SUBJECT: OYSTER CREEK NUCLEAR GENERATING STATION - STAFF ASSESSMENT OF INFORMATION PROVIDED PURSUANT TO TITLE 10 OF THE *CODE OF FEDERAL REGULATIONS* PART 50, SECTION 50.54(f), SEISMIC HAZARD REEVALUATIONS FOR RECOMMENDATION 2.1 OF THE NEAR-TERM TASK FORCE REVIEW OF INSIGHTS FROM THE FUKUSHIMA DAI-ICHI ACCIDENT (CAC NO. MF5257)

STAFF ASSESSMENT BY THE OFFICE OF NUCLEAR REACTOR REGULATION

RELATED TO SEISMIC HAZARD AND SCREENING REPORT

OYSTER CREEK NUCLEAR GENERATING STATION

Figure 3.3-1 Plot of Staff's and Licensee's Base Case Shear-Wave Velocity Profiles at the Oyster Creek site

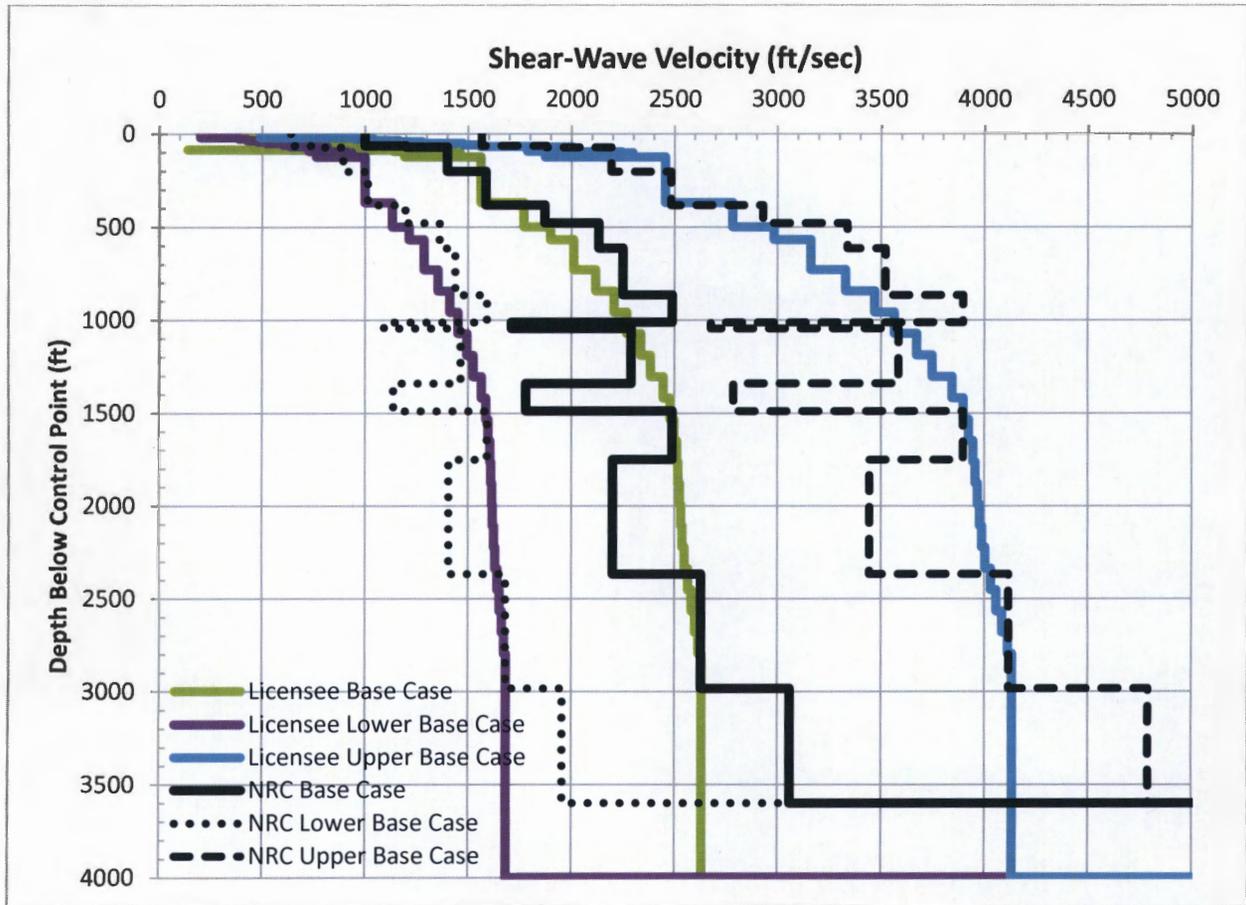
To account for uncertainty in the subsurface shear wave velocities, the licensee developed three site base case profiles. The middle, or best estimate, profile was developed by matching the measured shear-wave velocity from standard penetration tests in the upper 300 ft. (91 m). To develop the shear wave velocities for the deeper layers of the profile, the licensee used the shear wave velocity templates provided in the SPID. As such, the resulting base-case profile consists of the measured velocities for the upper layers combined with the adjusted template extended to the profile to basement rock. To develop the upper and lower base case profiles, the licensee used a natural log standard deviation of 0.35, which reflects the rather large uncertainty in the shear wave velocity. Figure 3.3-1 of this assessment shows the licensee's three shear-wave velocity base case profiles.

Following the guidance provided in the SPID for sites with less subsurface information, the NRC staff determined best-estimate and upper and lower base case shear-wave velocity profiles. Site investigations at the Oyster Creek site extended to a depth of approximately 120 ft. (37 m) (Exelon, 2013). The NRC staff used UFSAR thicknesses and velocities for the Cohansey sand and Lower Clay units that extend from the control point to 78 ft. (24 m). Below this depth, there is little subsurface information, so the NRC staff based its best-estimate velocity profile on information in the well logs associated with the International Ocean Drilling Project (IODP). Two onshore IODP sites are located within 20 mi (32 km) of the site (Browning, et al., 2011 and Miller, et al., 1998), which contain information about soil and rock material properties and unit thicknesses to a depth of approximately 1,500 ft. (457 m). Because geologic formations across the state are continuous and relatively uniform (Horace et al., 1983; Sugarman, et al., 2011), the NRC staff used the shear-wave velocities in the SSAR for the PSEG site (PSEG, 2014) for the soil and rock units identified from the onshore well logs. To account for the uncertainty in the shear wave velocities, the NRC staff used a natural log standard deviation of 0.35 to calculate the upper and lower base case profiles. Figure 3.3-1 of this assessment shows a comparison of the licensee's velocity profile with that developed by the NRC staff. The profiles developed by the licensee are similar to those developed by the NRC staff, but have less variability in seismic velocities due to the use of a template velocity profile. The NRC staff randomized the depth to reference rock by ± 10 percent to allow for additional uncertainty.

Figure 3.3- 2 Plot Comparing the Staff's and the License's Median Amplification Functions and Uncertainties for two input loading levels at the Oyster Creek site

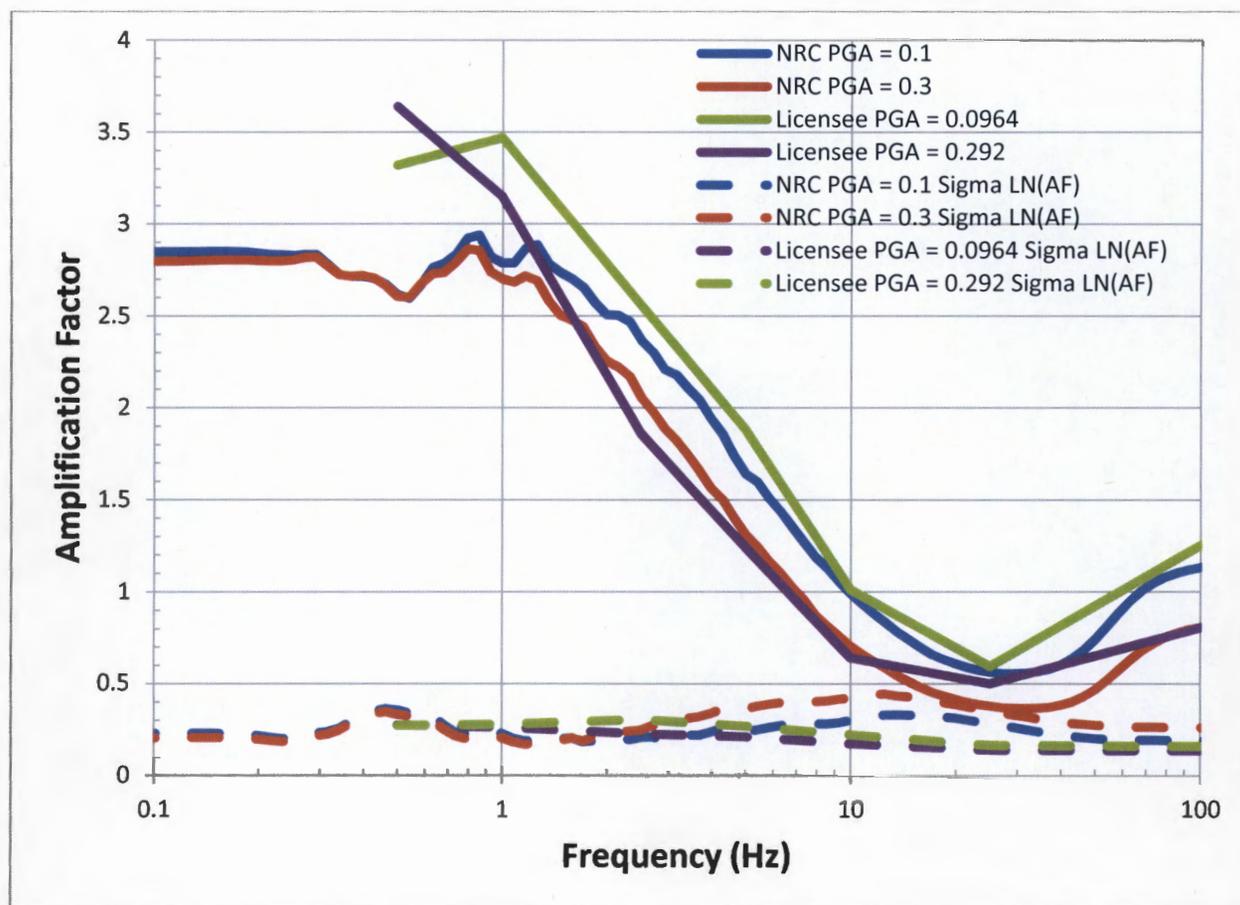
Figure 3.3-2 of this assessment shows a comparison of the staff's and the licensee's median site amplification function and uncertainties (± 1 standard deviation) for two of the eleven input loading levels. Amplification functions developed by both the licensee and the NRC staff are greatest at less than 1 Hz, decreasing in amplitude with increasing frequency until approximately 25 Hz. Minor differences in amplification functions developed by the NRC staff and the licensee are due to differences in depth to reference rock, the use of template velocities by the licensee, and the use of lower velocities near the surface by the licensee.

The licensee's approach to modeling the subsurface properties and their uncertainties results in similar amplification factors to those developed by the NRC staff. Figure 3.3-3 of this assessment shows a comparison of the licensee and NRC soil hazard curves. The licensee's curves are nearly identical to the staff's at 10 Hz and 100 Hz (PGA), but are slightly higher at 1 Hz. These differences in control point hazard curves have a minor impact on the resulting GMRS, discussed below. Appendix B of the SPID provides guidance for performing site response analyses, including capturing the uncertainty for sites with less subsurface data; however, the guidance is neither entirely prescriptive nor comprehensive. As such, various approaches in performing site response analyses, including the modeling of uncertainty, are acceptable.

Figure 3.4-1 Comparison of the Staff's GMRS with Licensee's GMRS and the SSE for Oyster Creek.

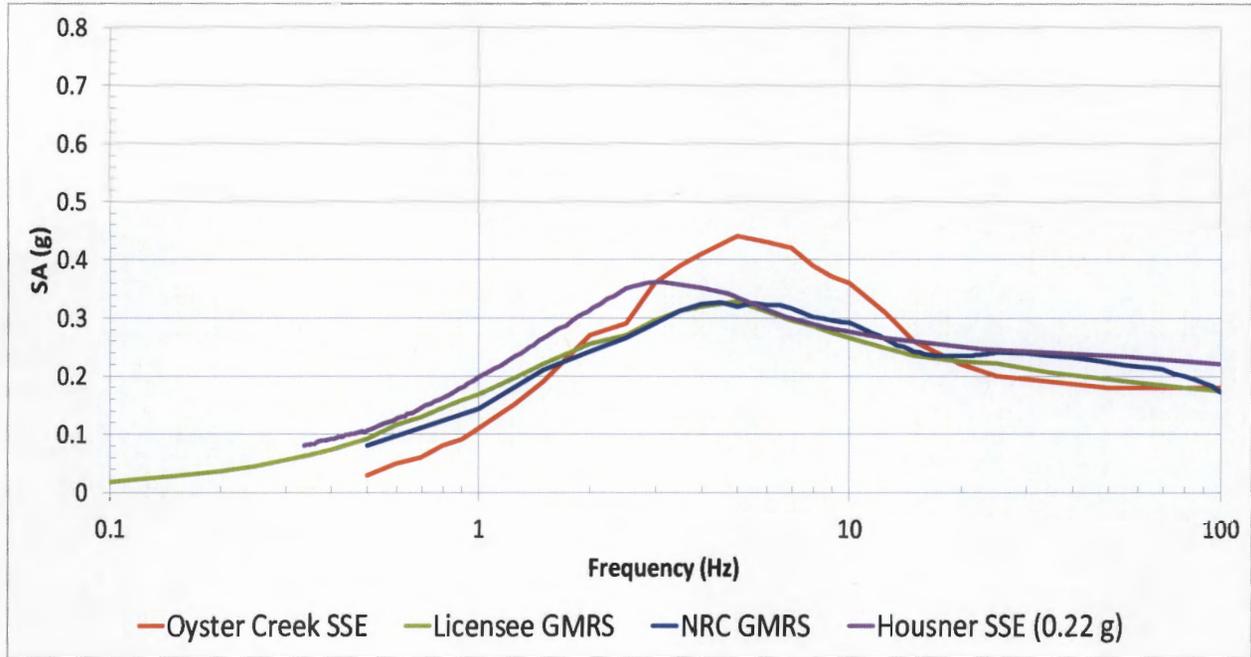
The NRC staff independently calculated the 10^{-4} and 10^{-5} UHRS using the results of its confirmatory PSHA and site response analyses, as described in Sections 3.2 and 3.3 of this staff assessment, respectively. Figure 3.4-1 of this assessment shows a comparison of the GMRS determined by the licensee to that determined by the NRC staff.

As shown in Figure 3.4-1, the licensee's GMRS shape is generally similar to that calculated by the NRC staff. The licensee's GMRS is higher than the staff's below approximately 5 Hz, and lower beyond. Minor differences in the shape and amplitude of the GMRS are due to differences in site response analyses as discussed above.

The NRC staff confirms that the licensee used the present-day guidance and methodology outlined in RG 1.208 and the SPID to calculate the horizontal GMRS, as requested in the 50.54(f) letter. The NRC staff performed both a PSHA and site response confirmatory analysis and achieved results consistent with the licensee's GMRS. As such, the NRC staff concludes that the GMRS determined by the licensee adequately characterizes the reevaluated hazard for the Oyster Creek site. Therefore, this GMRS is suitable for use in subsequent evaluations and confirmations, as needed, for the response to the 50.54(f) letter.
